From: Low, Tim
Sent: Thursday, March 26, 2015 9:33 PM
To: Miles, David
Cc: Smith, Sandra M; Sandercock, Deborah; Labayog, Edward; Clarke, Gregory M; Minor, Gregory; Taylor, Marie (Allene)
Subject: RE: Multiple Violations of the Implied Warranty of Habitability - Today: No warnings prior to disturbing asbestos / lead paint in a 1920s apartment building

Subject: RE: Multiple Violations of the Implied Warranty of Habitability - Today: No warnings prior to disturbing asbestos / lead paint in a 1920s apartment building

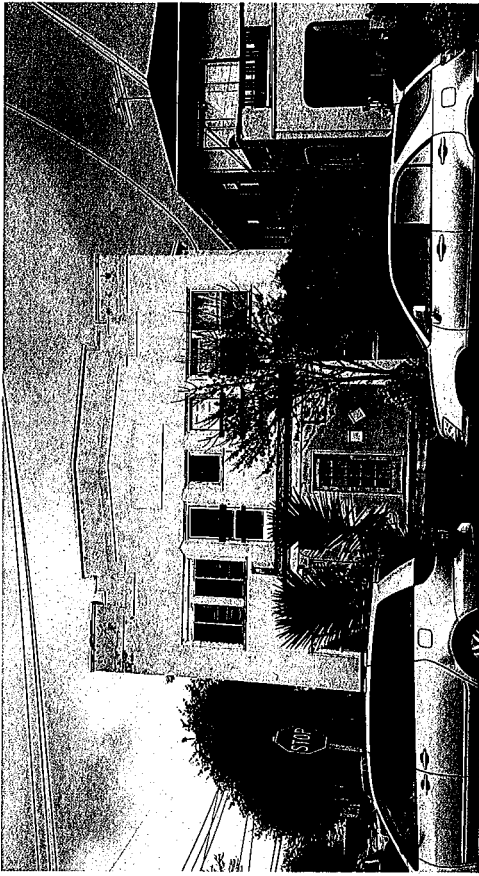
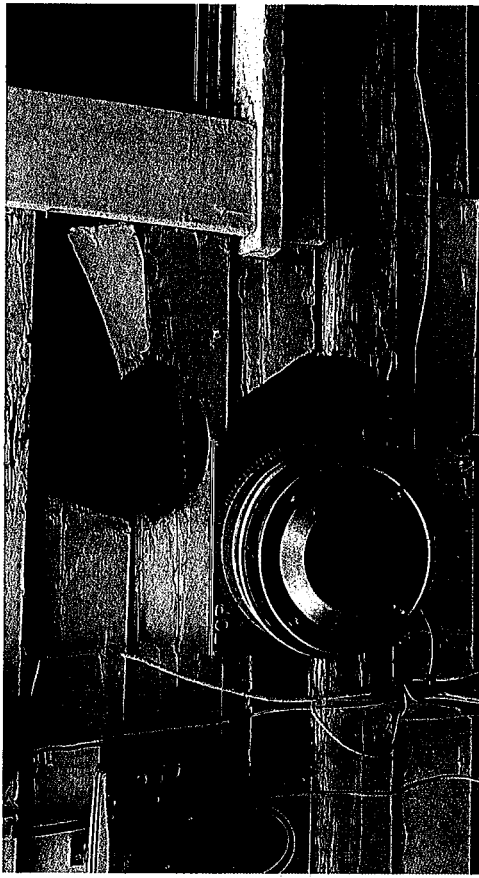
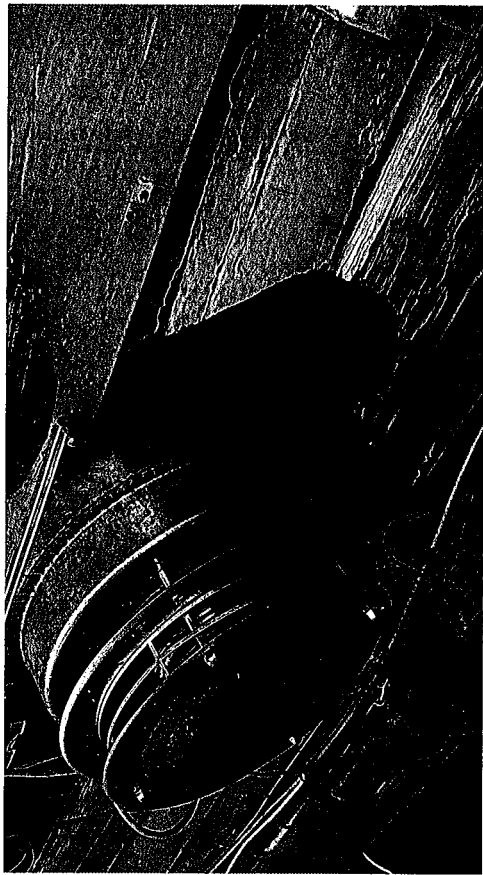
Photo 25	Close Up - Post imbedded in A/C Paving	Photo 26	Opening in stucco cracks
Photo 27	Deck settling - open joint	Photo 28	Close Up - Deck settling - open joint
Photo 29	Excessive holes in siding	Photo 30	Failed Siding
Photo 31	Surface Mounted Flashing w/ void at top	Photo 32	Surface Applied Flashing – Not Permitted
Photo 33	Deteriorated Electric Panel Enclosure	Photo 34	Close Up – Decay @ Electric Panel Enclosure
Photo 35	Rusting Service Panels	Photo 36	Negative Slope at Vent
Photo 37	Open Joints, Efflorescence	Photo 38	Leaking Plumbing, Valves frozen shut
Photo 39	Decay At Exterior Window Sills	Photo 40	Decay at Interior Window Sills
Photo 41	Deterioration at Interior Window Sills	Photo 42	Deterioration at Exterior Window Sashes
Photo 43	Deterioration at Exterior Window Sashes	Photo 44	Exterior Door No Tempered Glass
Photo 45	Decay/Deterioration @ Entry Door	Photo 46	Close Up of Decay/Deterioration @ Entry Door

Photo 47	Failure/Decay @ Interior Face of Ext Walls	Photo 48	Failure/Decay @ Interior Face of Ext Walls
Photo 49	Failure/Decay @ Interior Face of Ext Walls	Photo 50	Failure/Decay/Mold @ Interior Face of Ext Walls
Photo 51	Failure/Decay @ Interior Face of Ext Walls	Photo 52	Failure/Decay @ Interior Face of Ext Walls
Photo 53	Decay/Mold @ Interior Face of Ext Walls	Photo 54	Open Electrical Receptacle
Photo 55	Failure/Decay @ Ceilings	Photo 56	Failure/Decay @ Ceilings
Photo 57	Failure/Decay @ Ceilings	Photo 58	Failure/Decay/Mold @ Ceilings
Photo 59	Decayed Framing/Unprotected	Photo 60	Decayed Framing/Unprotected
Photo 61	Deteriorated Finish Flooring
